SUBJECT: Transmittal of Responses to AP1000 DSER Open Items

Draft Safety Evaluation Report Open Item Response

Figure 15.2.7-1 DEDVI: Intact IRWST Injection Flow

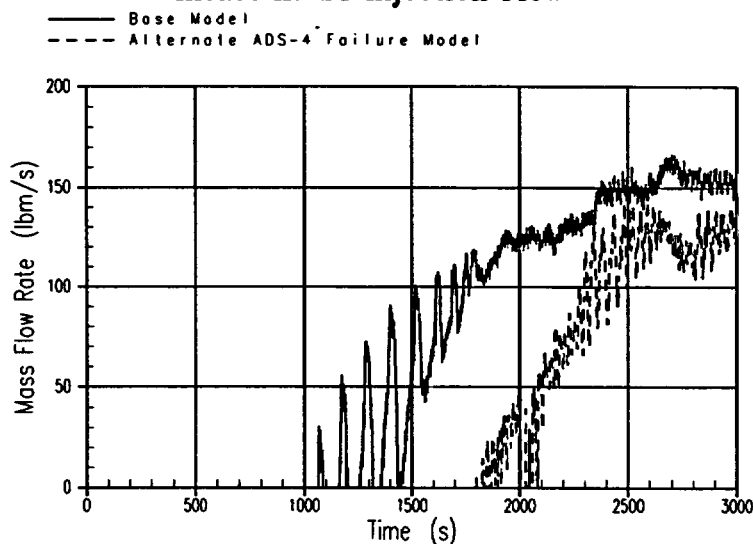
Tests at the AP1000 APEX facility indicate that the single failure of a stage 4-ADS valve produces lower core inventories if the failed valve is not in the pressurizer loop. The revised DCD Section 15.6.5.4C.2 (DSER OI 15.2.7-1P Page 14) states that the analysis of the DEDVI LTC case assumes failure of one of the two ADS-4 valves in the PRHR loop. Since the PRHR loop is the same loop that contains the pressurizer, justify that the small break analyses in Chapter 15 of the DCD are conservative in view of the test results from the APEX facility.

As was observed in the AP1000 APEX facility, the ADS Stage 4 valve failure on the non-pressurizer side (ADS 4-1) resulted in a delay in the onset of IRWST injection flow (Figure 15.2.7-1). This can also be observed in the intact DVI line injection line flow as well (Figure 15.2.7-2). However, as observed in the AP1000 APEX simulations, the effect on the core/upper plenum two-phase mixture is minimal (Figure 15.2.7-3) with significant margin to core uncover being observed.

With the assumed failure in the ADS 4-1 path, RCS depressurization is slowed (Figure 15.2.7-13) and IRWST injection is delayed (Figure 15.2.7-1); however, the vessel inventory is only minimally altered (Figure 15.2.7-6). A review of the pressurizer inventory (Figure 15.2.7-14) indicates that the initial decrease in ADS 4-1 discharge can be attributed to a combination of the failure assumption in the ADS 4-1 path and the mass storage differences in the pressurizer. This pressurizer mass storage behavior was also observed in the AP1000 APEX tests. The difference in pressurizer mass dominates until IRWST injection begins at which time excess inventory is discharged via the ADS 4 paths (Figure 15.2.7-9). No significant change in ADS-4 vapor discharge is observed between the two simulations (Figure 15.2.7-15).

Figure 1: Containment Backpressure for DEDVI

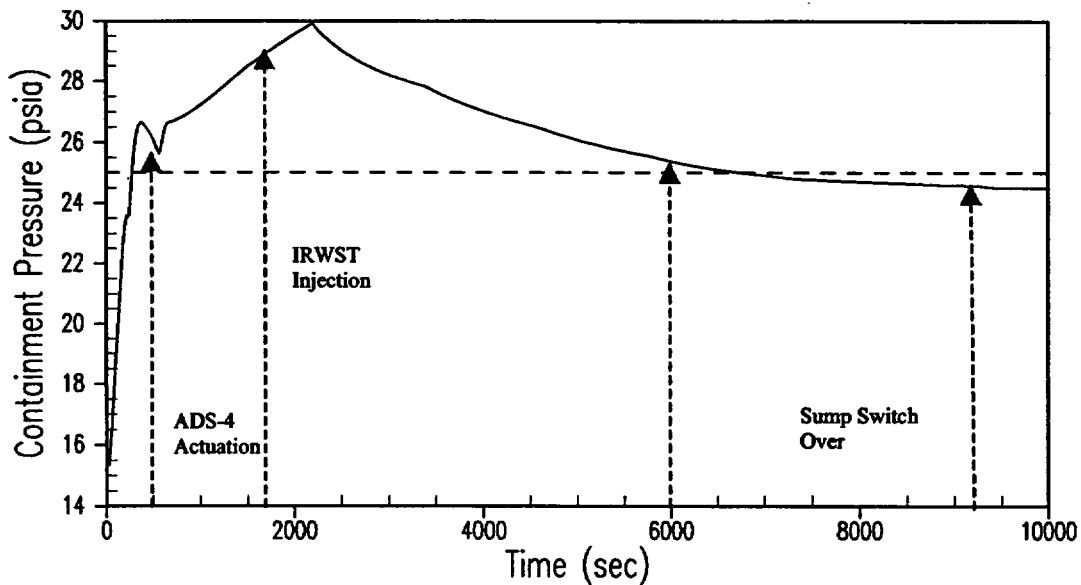
The revised DCD Section 15.6.5.4C (DSER OI 15.2.7-1P Page 14) states that the LTC phase analysis uses the NOTRUMP DEDVI case at 25 psia containment pressure reported in Section 15.6.5.4B as initial conditions, and the WGOETHIC analysis of this event as boundary conditions.

The containment pressure for this event is shown in Figure 1. Also shown are the times for ADS-4 actuation, IRWST actuation and switch over to sump recirculation. This figure shows that 25 psia is an acceptable backpressure for the DEDVI LOCA analysis for the time period following the initial blowdown until the initiation of sump injection. For the first 200 seconds, the pressure is below 25 psia, but during this time, the RCS pressure is high and the containment backpressure has little effect on the plant response. At the time of IRWST injection, the backpressure is well above 25 psia. As the IRWST drains, the pressure continues to fall reaching approximately 24.5 psia at sump recirculation. Thus, for the short-term analysis, the backpressure of 25 psia is a conservative limit. A lower pressure boundary condition is appropriate for times after sump recirculation is established.

Figure 21.5-1.12 ADS-4 Liquid Discharge Comparison

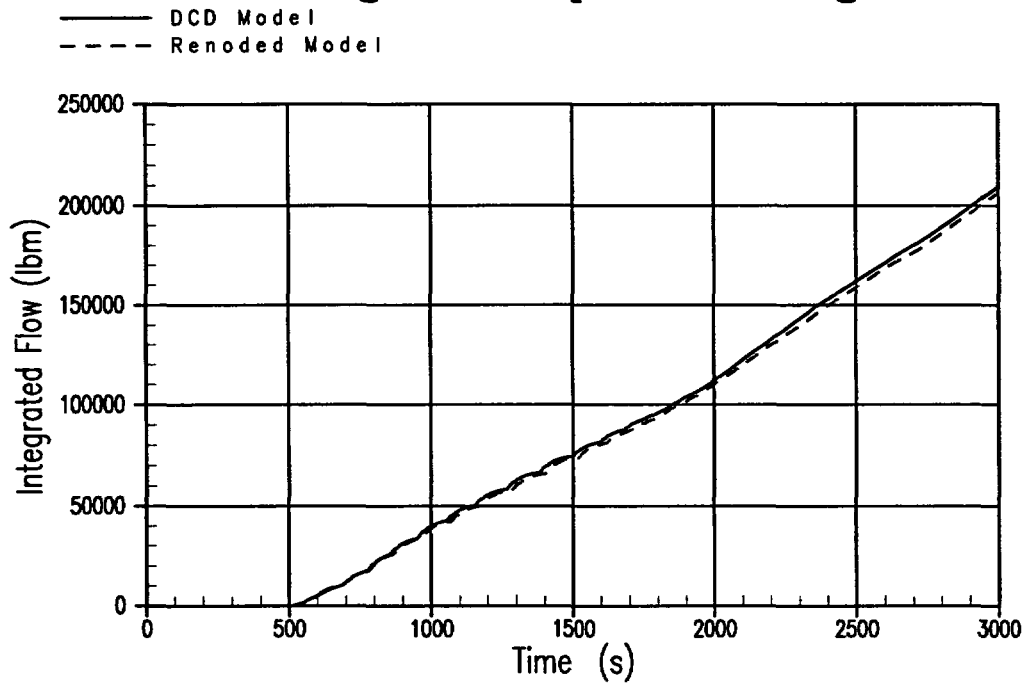
For the comparison of the integrated liquid discharge through ADS-4 between the base DCD case and the revised nodding model, Figure 21.5-1.12 on DSER OI 21.5-1P Page 11 has an inconsistency in that the heading states "ADS-4 Liquid Discharge Comparison" whereas the actual figure is for ADS-4 integrated vapor discharge.

Please clarify.

Figure 21.2.1-12 was intended to be a plot of ADS-4 Liquid Discharge Comparison. However the figure that was included was ADS-4 integrated vapor discharge as the Item states. The attached figure is the corrected Figure 21.5-1.12 that shows ADS-4 Liquid Discharge Comparison.

Figure 21.5-1.14 Downcomer Pressure Comparison

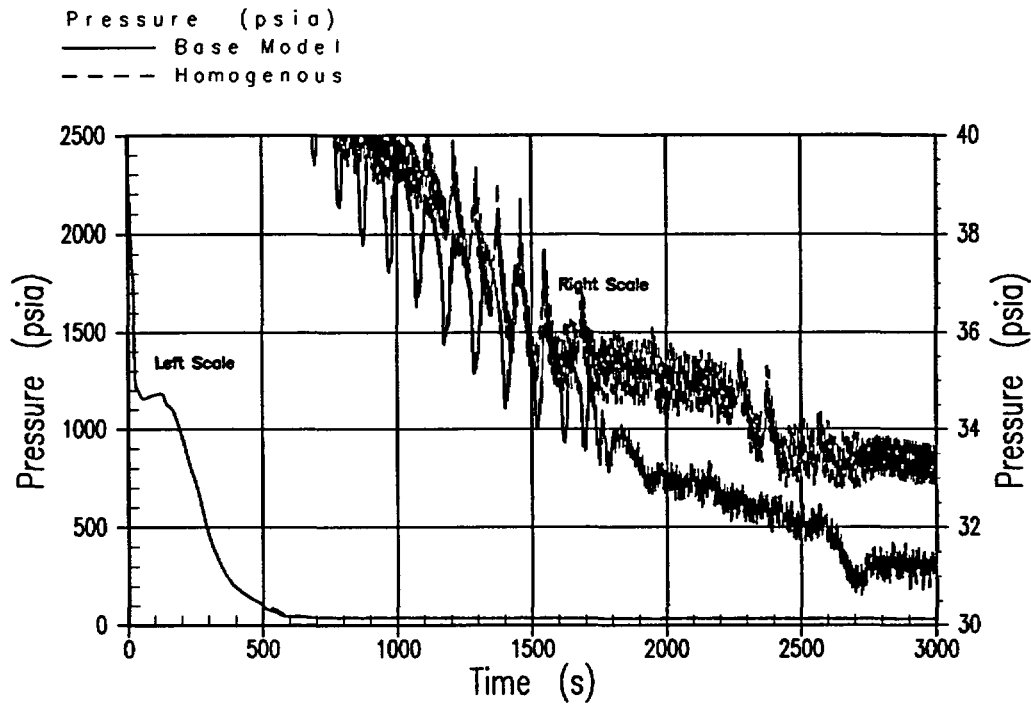
The text on DSER OI 21.5-1P Page 3 states that Figure 21.5-1.14 presents a comparison of the upper downcomer pressure between the base case and the sensitivity case, but the actual figure is for pressurizer pressure (except for the heading). The text also states that the pressurizer mixture level response (Figure 21.5-1.25) reflects the change in pressure response (Figure 21.5-1.14) observed in the model.

Clarify the discrepancy regarding Figure 21.5-1.14.

Figure 21.5-1.14 was intended to show the upper downcomer pressure between the base case and the sensitivity case, but the actual figure is incorrect as stated in Item 17 above. The attached figure provides the corrected Figure 21.5-1.14. The plot of Pressurizer pressure is also provided as 21.5-1.26 and the text should refer to this figure for pressurizer pressure. No update to the previous response is intended.
